**BUILDINGS 5 & 6
 RENOVATIONS**
 San Mateo County Community
 College District

CAÑADA COLLEGE
 4200 Farm Hill Boulevard
 Redwood City, CA 94061

THIRD FLOOR
 FINISH AND SIGNAGE PLAN

Date 08/29/08 Drawing Number
 Scale AS NOTED **A9.43**
 Project Number 07013

THIRD FLOOR FINISH AND SIGNAGE PLAN

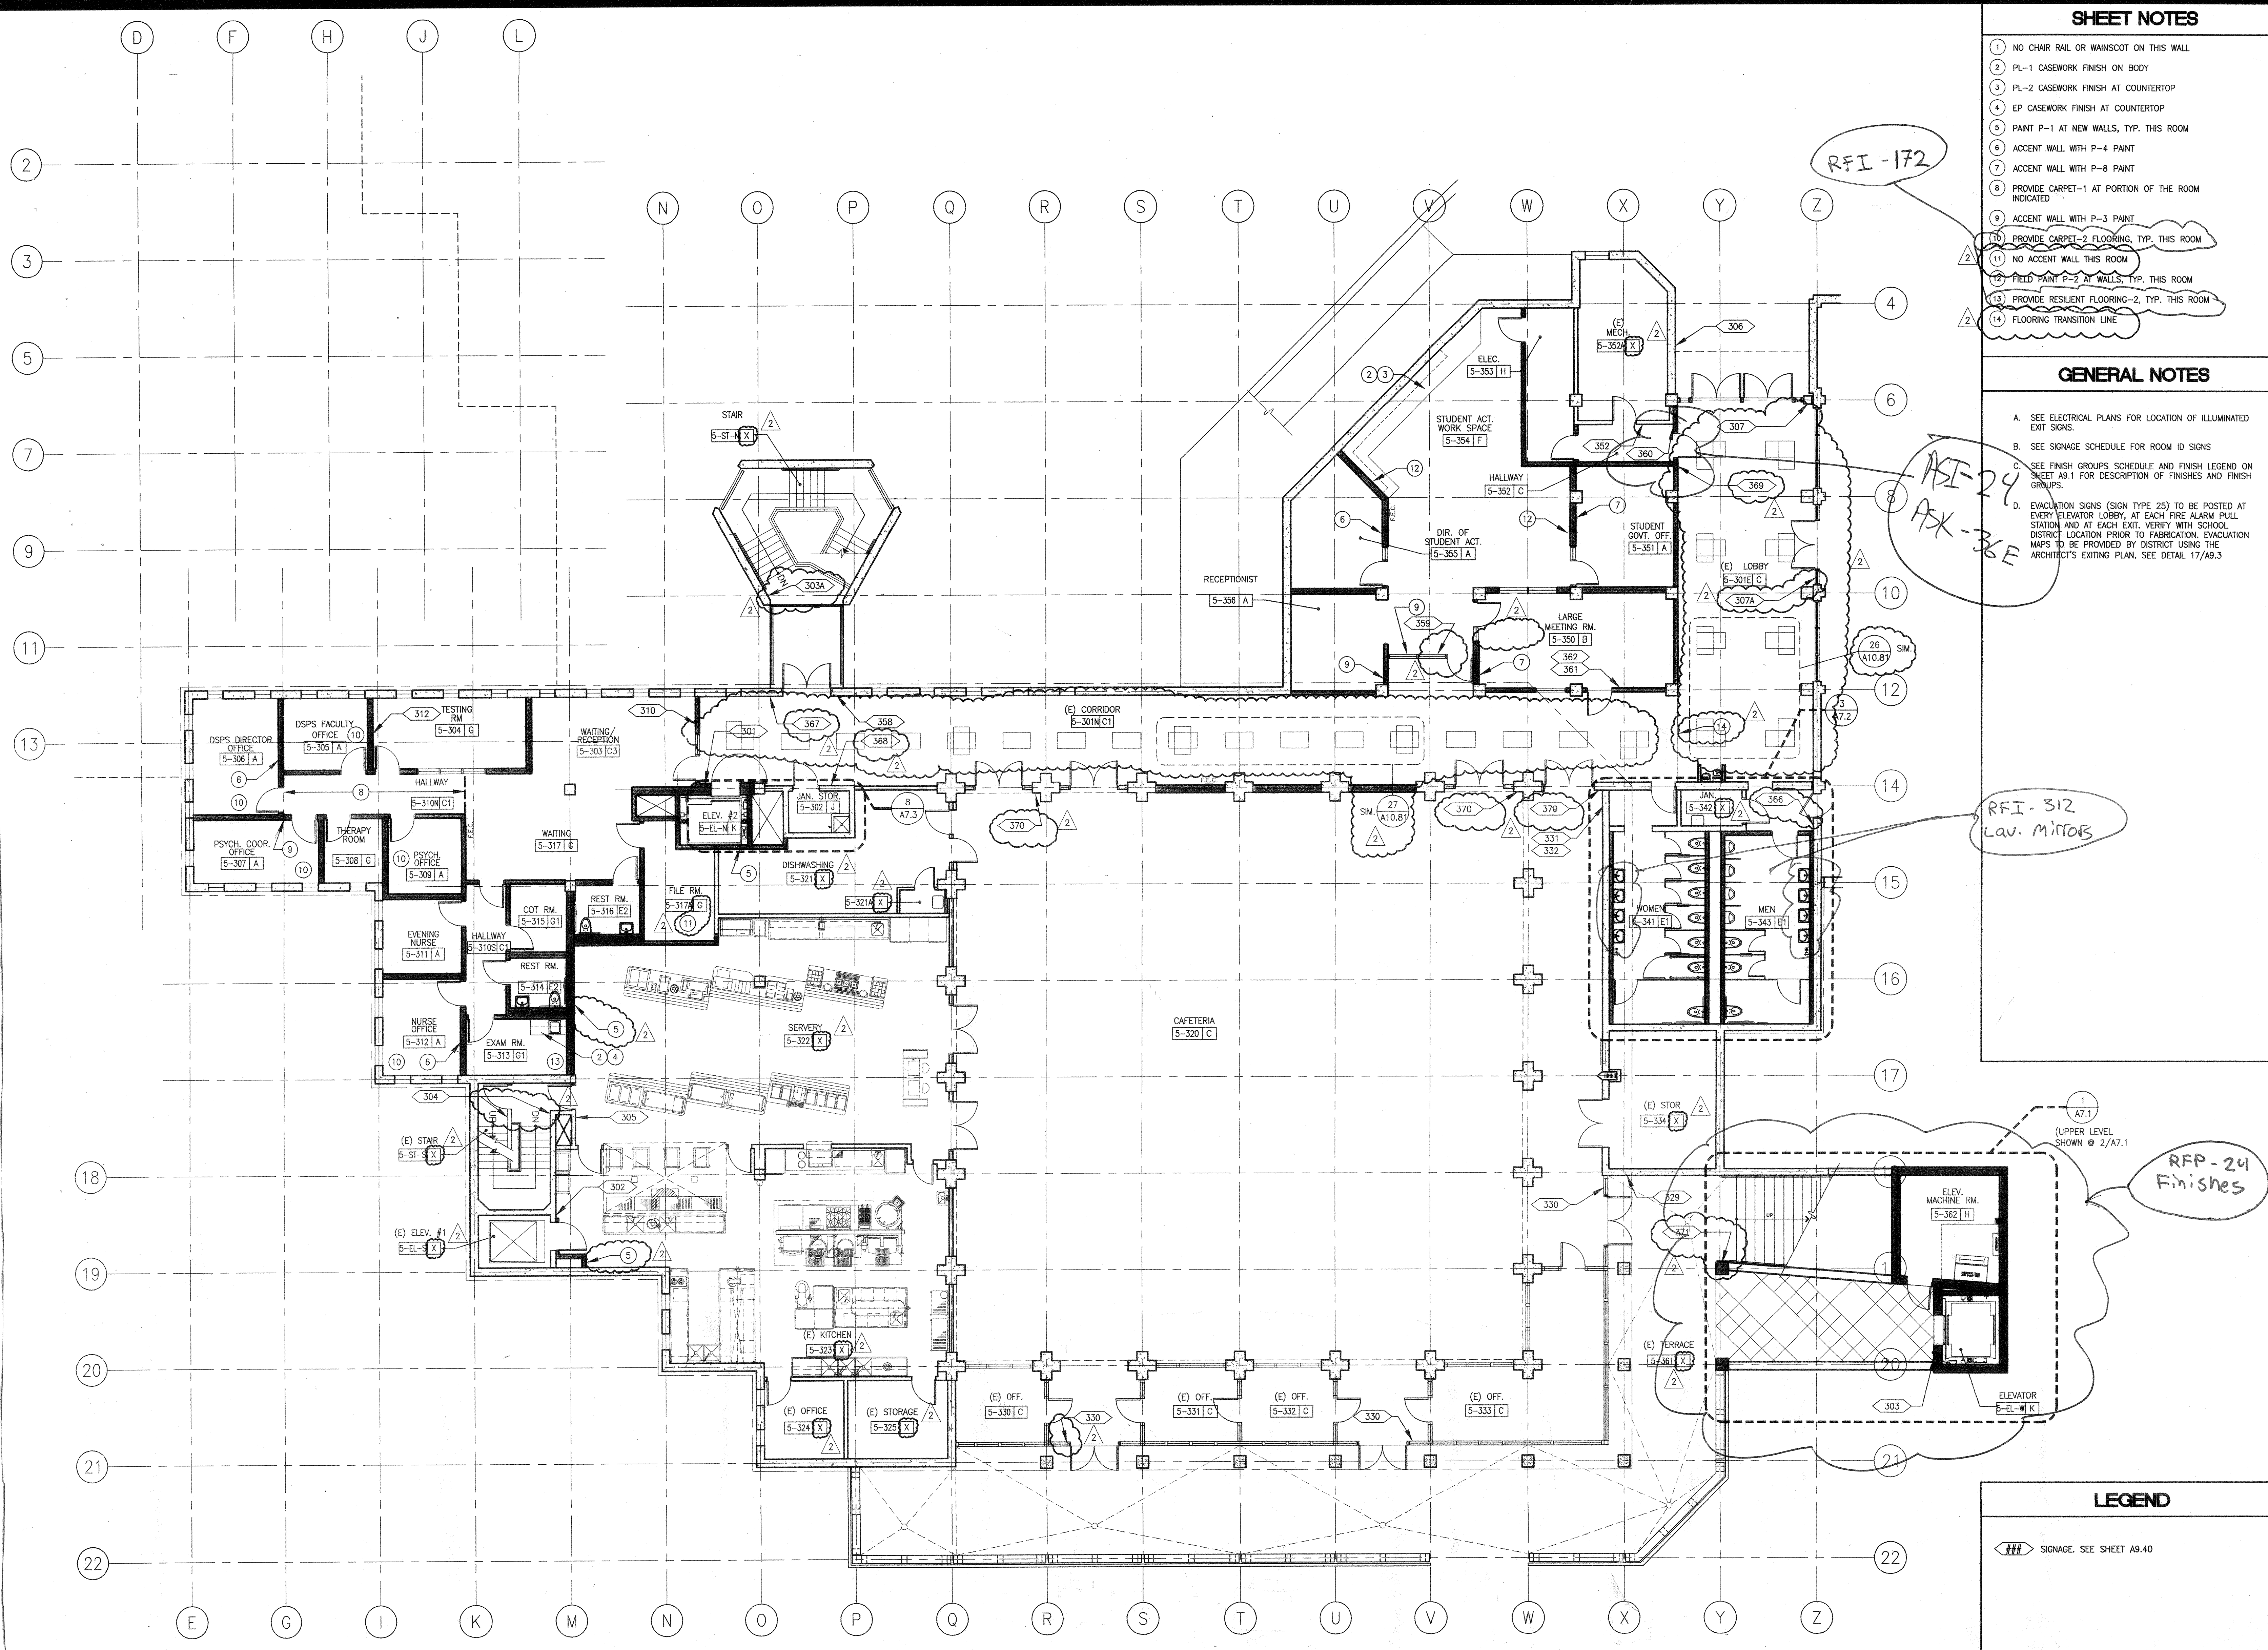
RFI-172

RFI-29
 ASX-36E

RFI-312
 Lav. Mirrors

RFI-24
 Finishes
